Board of County Commissioners Summary Report

Case name: **PM22-006**
Arcadia Creek

RE: Arcadia Creek – Variance Requests to the Private Access

Re: Revised Variance Request Arcadia Creek
Technical Review Committee

2 CHRISTENSEN LANE: SECTION A-A'

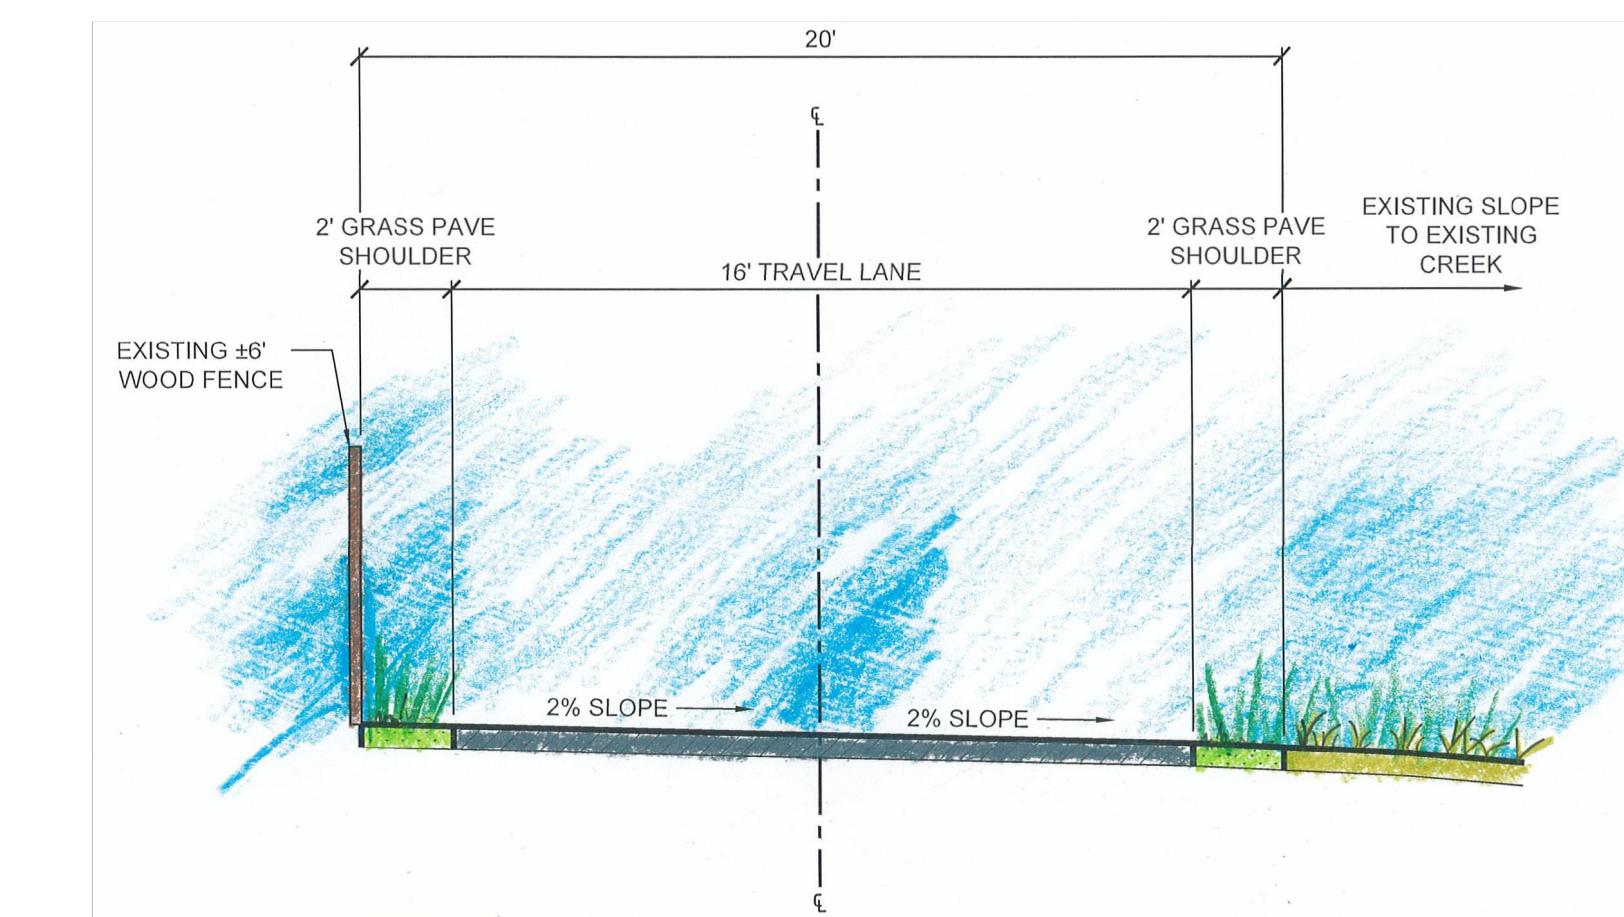
- The proposed cross section of the private access and the gate use plan must be reviewed by the Fire District, and the Fire District's approval is required.

- Recommends "No Parking" signs along both sections of W. Christiansen Lane be installed. This should also be determined and approved by the Fire District.

- Clarify the intention of the pedestrian path – whether the path is open to the public or private.
- Public Use Easement is required through the pedestrian path section.

3 DRIVE: SECTION B-B'

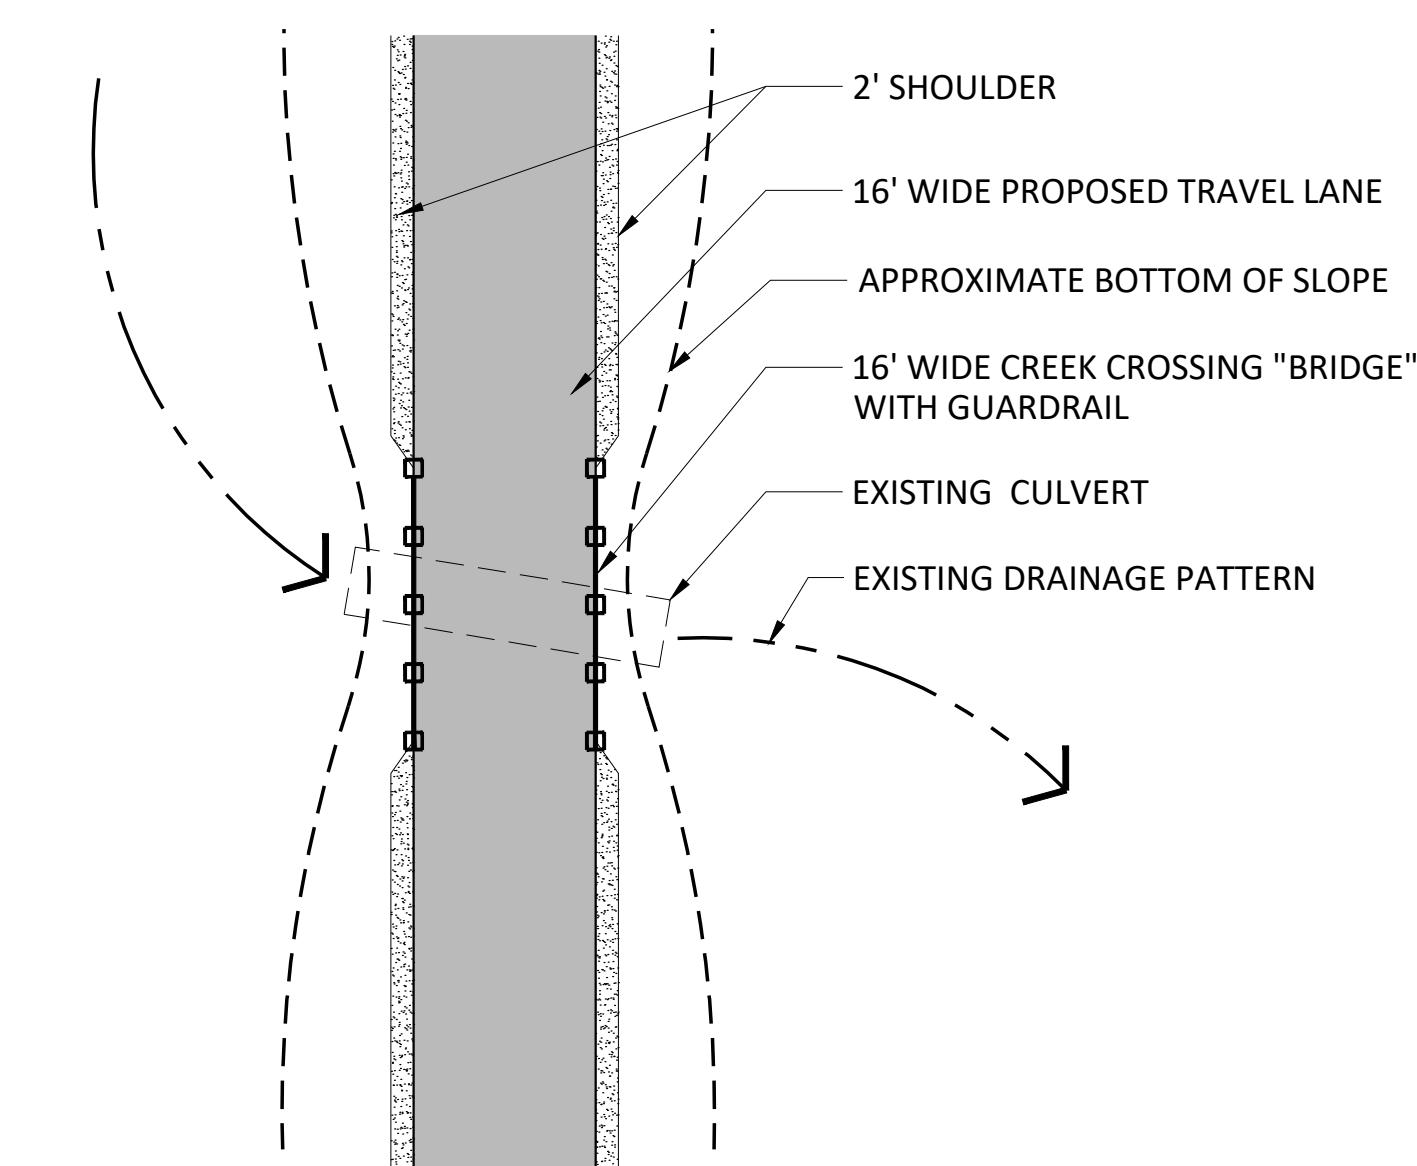
- The stream crossing at the private access/Coon Creek should be updated if this private access is being upgraded pursuant to the Phase B Preliminary Design Report for Dutch Creek, Coon Creek, Lilley Gulch and Three Lakes Tributary. The Mile High Flood District (MHFD) makes the recommendation to the design of this stream crossing.

- Concerns about the emergency access during a flood event. The Developer needs to verify if there is an access to a public road without going through a floodplain including the access in Jefferson County.

CHRISTENSEN LANE TYPICAL SECTION

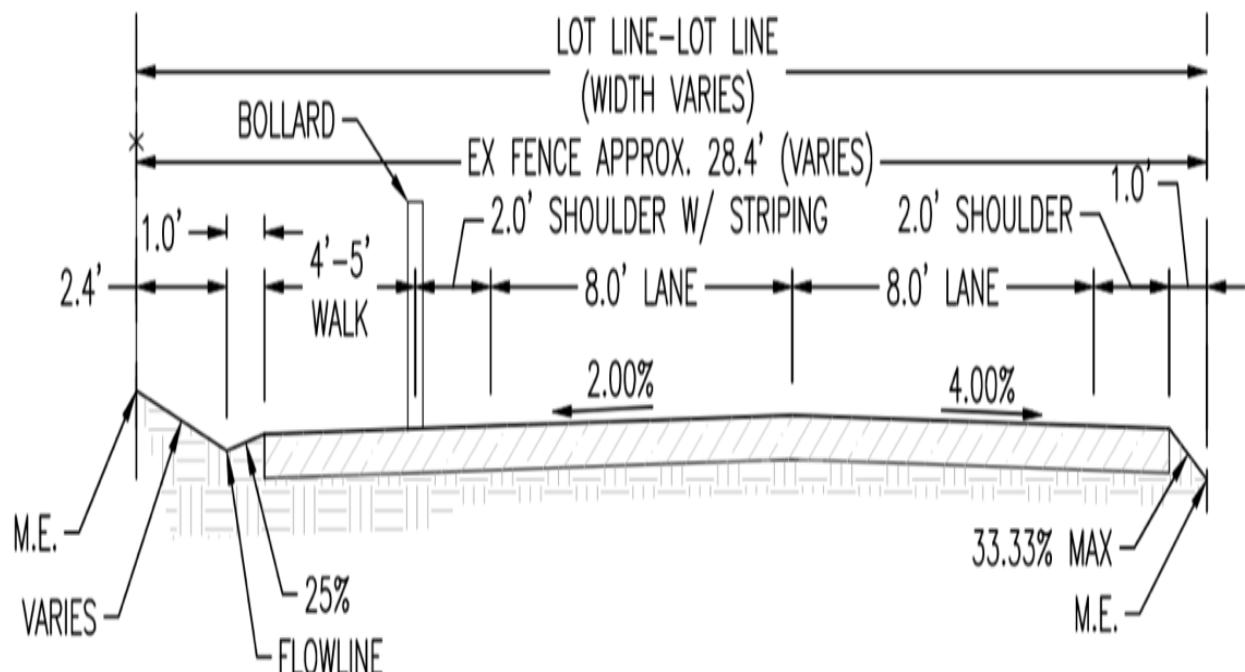
- a. TRC did not have any objection to the Culvert Design proposed. TRC suggested that the roadway edge signing/delineation be added.
- b. TRC mentioned that the South Metro Fire Rescue will need to see the new proposed design for requirements and approval.
- c. TRC supported variance for not requiring sidewalk along private road.
